HISTORIC AND DESIGN REVIEW COMMISSION

August 07, 2024

HDRC CASE NO: 2024-257
ADDRESS: 800 W RUSSELL PLACE
LEGAL DESCRIPTION: NCB 1877 BLK 5 LOTE 18.59 FT OF N 105.73 FT OF 7 & N 105.73 FT OF 8
ZONING: RM-4, HL
CITY COUNCIL DIST.: 1
APPLICANT: Eduardo Quintana/BCR BEST CONCEPT RENOVATIONS LLC
OWNER: Eduardo Quintana/BCR BEST CONCEPT RENOVATIONS LLC
TYPE OF WORK: Fenestration modifications, window replacement, siding replacement, and skirting modifications
APPLICATION RECEIVED: June 25, 2024
60-DAY REVIEW: August 24, 2024
CASE MANAGER: Rachel Rettaliata

The applicant is requesting a Certificate of Appropriateness for approval to:

ELEVATIONS EAST & WEST

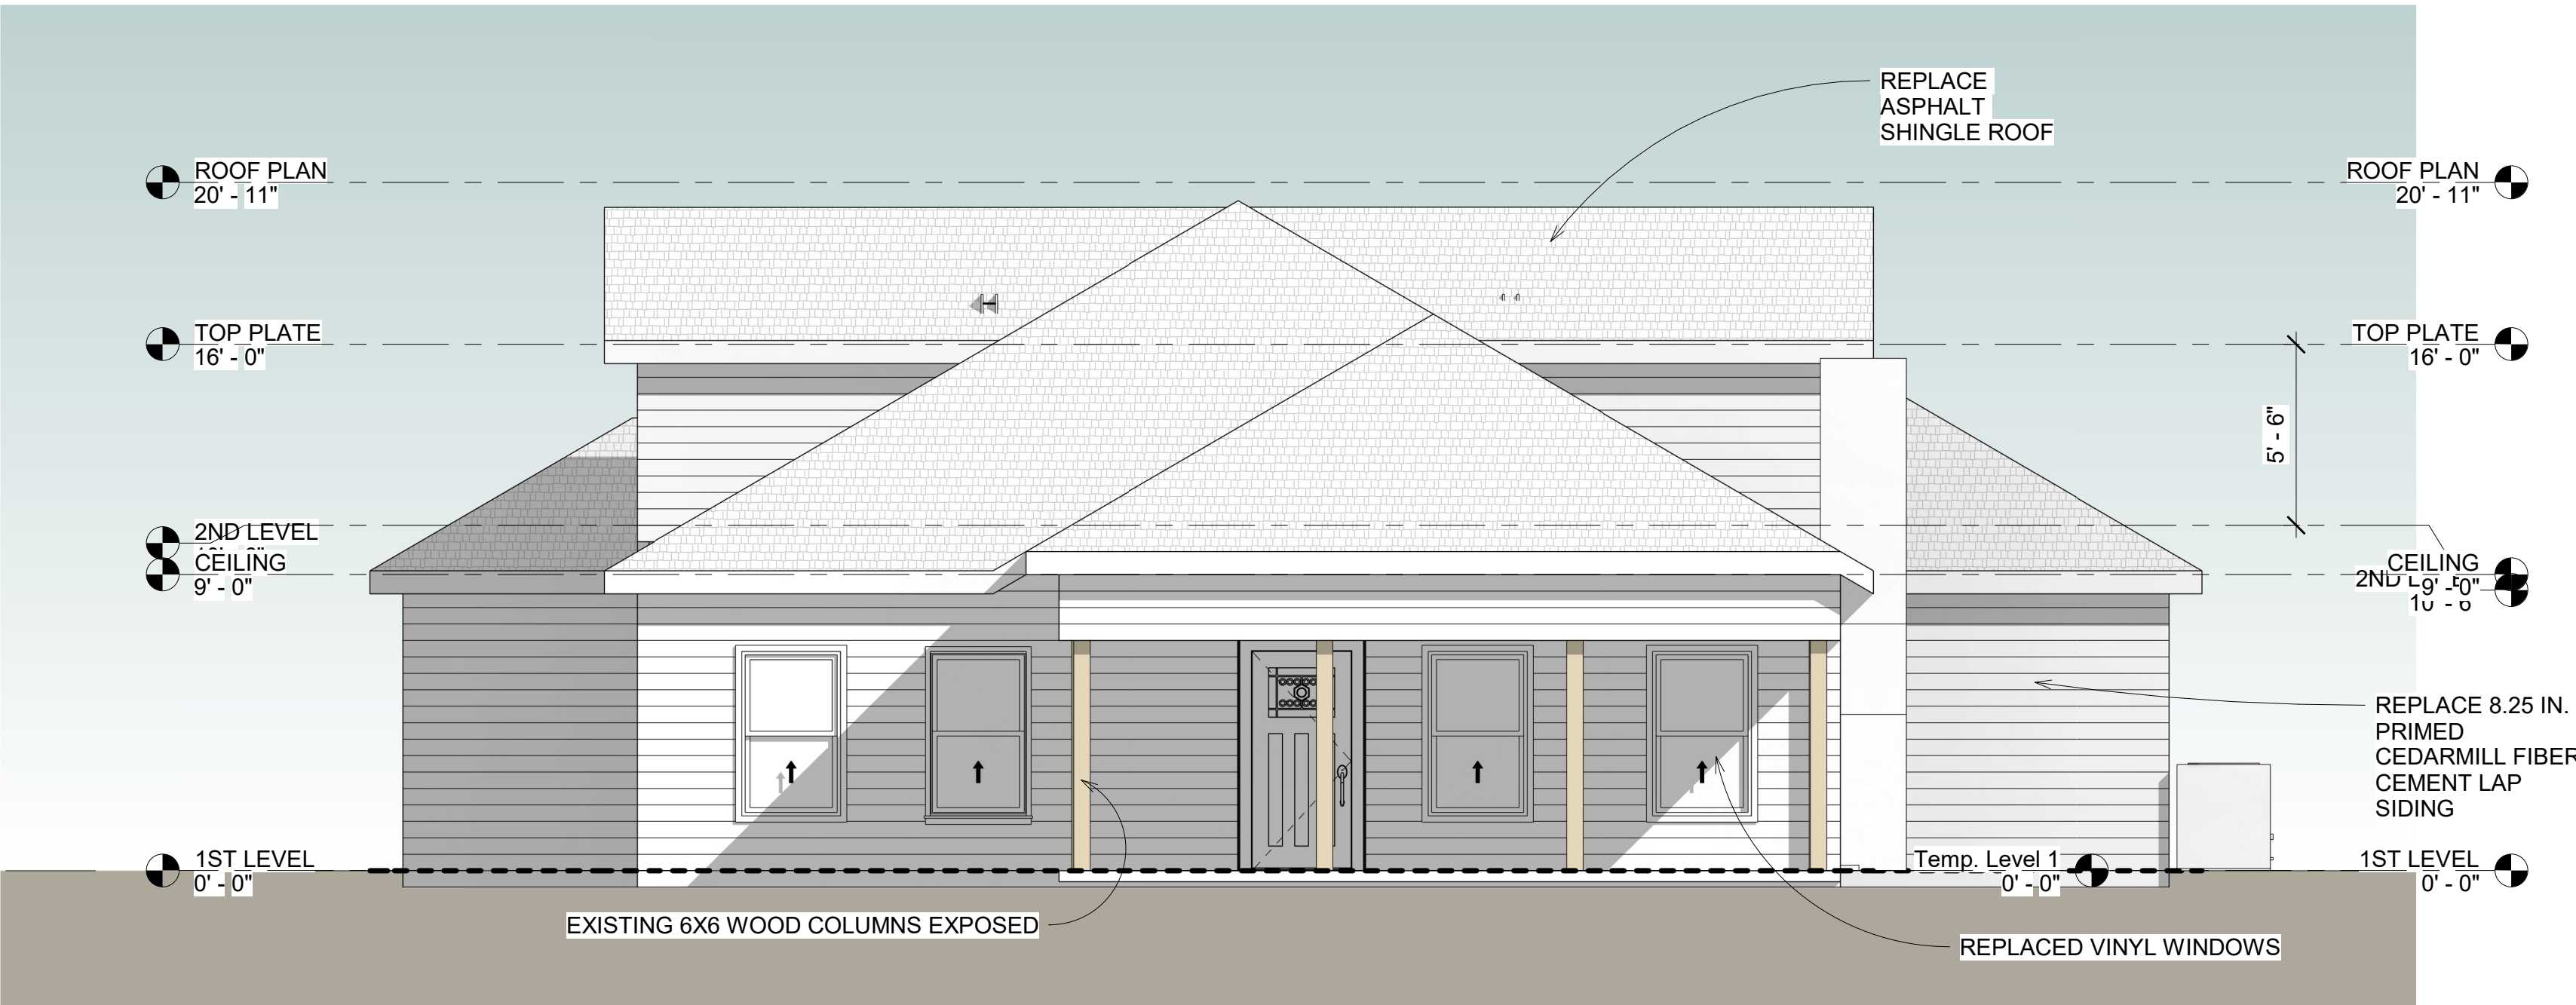
- f. FENESTRATION MODIFICATIONS (EAST ELEVATION) – The applicant has proposed to modify the fenestration pattern on the east elevation, facing N Flores Street, with the removal and infill of eight (8) window openings on the east elevation and the installation of one (1) fixed transom-style window in the dormer. Guideline 6.A.i for Exterior Maintenance and Alterations states that existing window and door openings should be preserved. Avoid enlarging or diminishing to fit stock sizes or air conditioning units. Avoid filling in historic door or window openings. Avoid creating new primary entrances or window openings on the primary façade or where visible from the public right-of-way. Additionally, Guideline 6.B.iv states that new windows should be installed to match the historic or existing windows in terms of size, type, configuration, material, form, appearance, and detail when original windows are deteriorated beyond repair. Staff finds the proposed fenestration modifications inconsistent with the Guidelines and finds that the original window opening locations and proportions should be retained.

- h. FENESTRATION MODIFICATIONS (WEST ELEVATION) – The applicant has proposed to infill five (5) windows on the west elevation and modify the set of three (3) ganged windows to two (2) windows, modify the two (2) ganged windows in the dormer to a single one-over-one window, and install one fixed window at the

Item 3, staff does not recommend approval of the proposed fenestration modifications based on findings f through h. Staff recommends that the original window opening locations and proportions are retained on the east, south, and west elevations. The applicant is required to submit updated elevations drawings to staff for review and approval prior to the issuance of a Certificate of Appropriateness.

ELEVATIONS NORTH & SOUTH

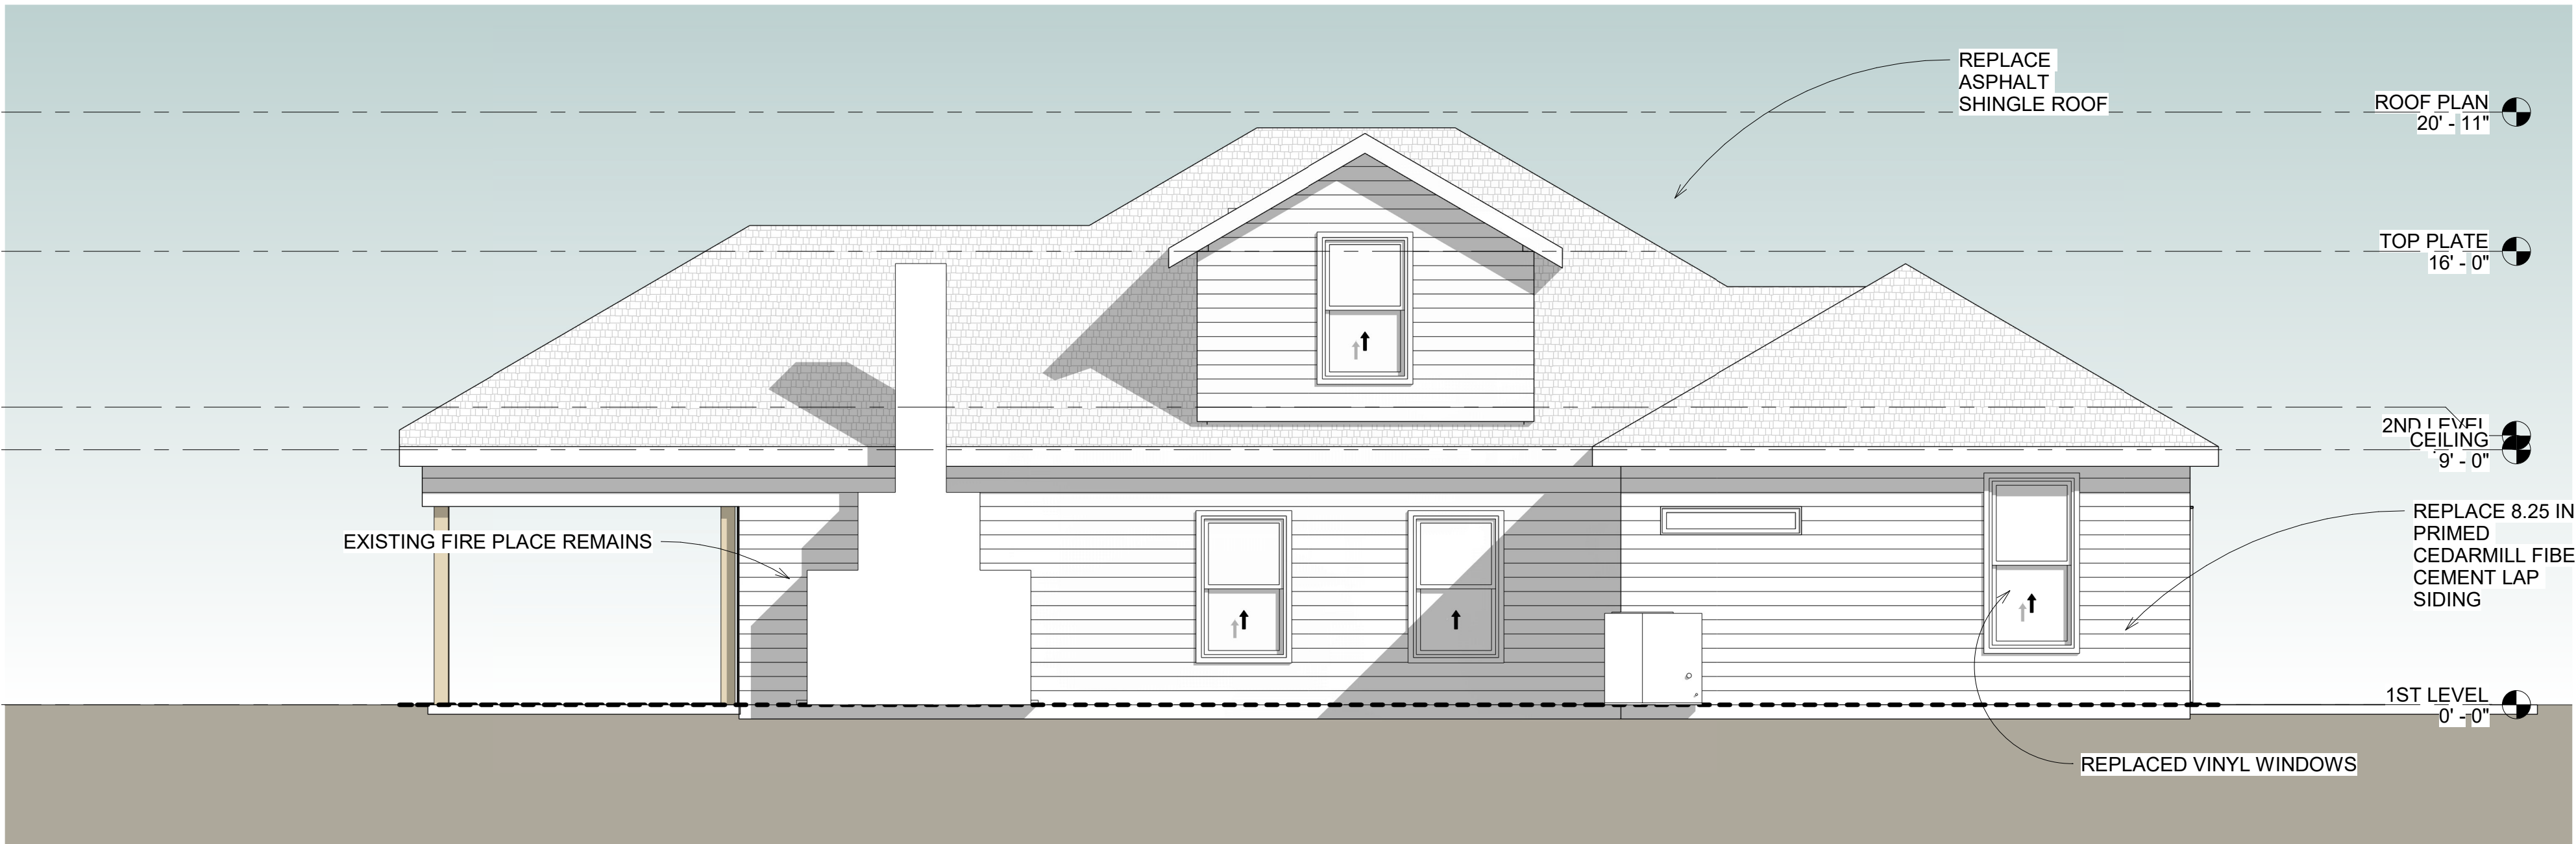
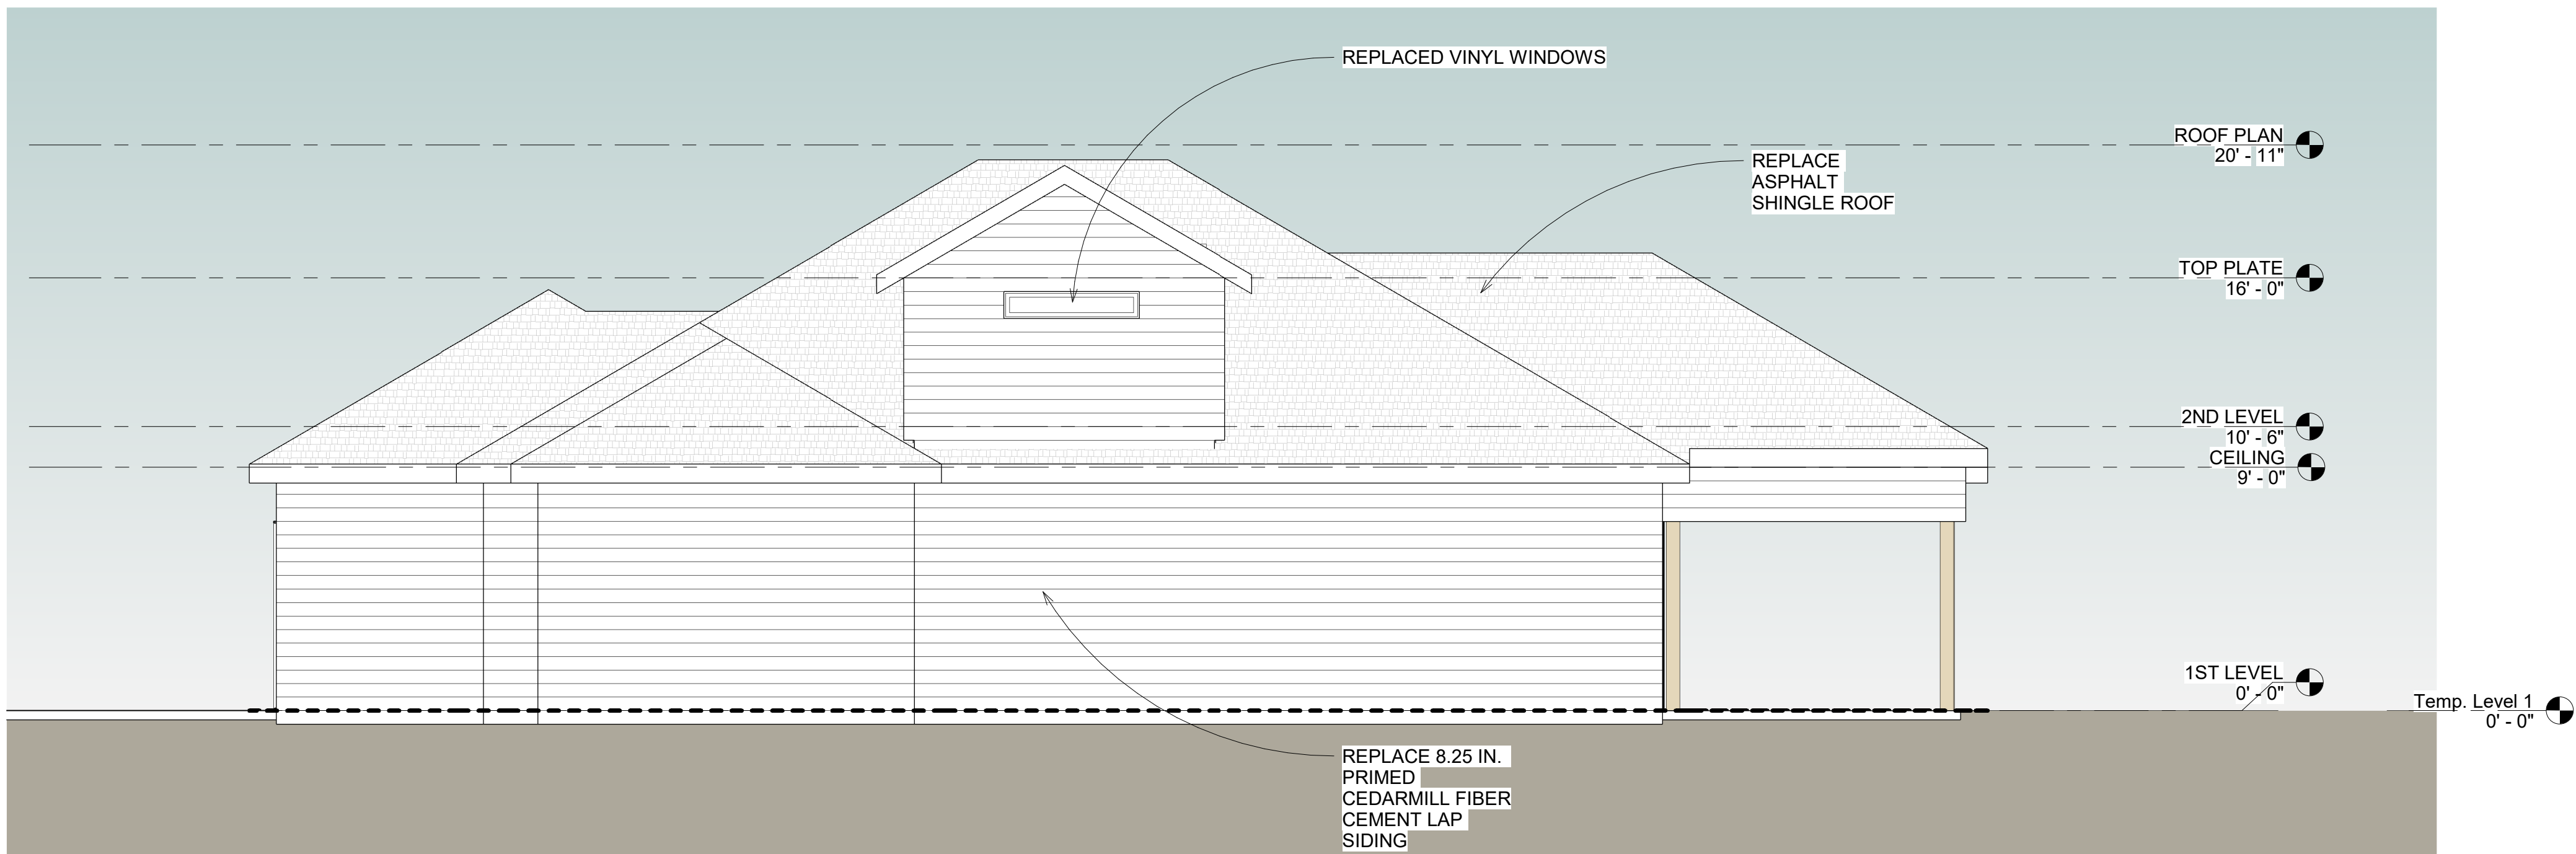
- g. FENESTRATION MODIFICATIONS (SOUTH ELEVATION) – The applicant has proposed to remove and infill two (2) windows on the south (rear) elevation and relocate two (2) windows on the south (rear) elevation. Guideline 6.A.i for Exterior Maintenance and Alterations states that existing window and door openings should be preserved. Avoid enlarging or diminishing to fit stock sizes or air conditioning units. Avoid filling in historic door or window openings. Avoid creating new primary entrances or window openings on the primary façade or where visible from the public right-of-way. Additionally, Guideline 6.B.iv states that new windows should be installed to match the historic or existing windows in terms of size, type, configuration, material, form, appearance, and detail when original windows are deteriorated beyond repair. Staff finds the proposed fenestration modifications inconsistent with the Guidelines and finds that the original window opening locations and proportions should be retained.
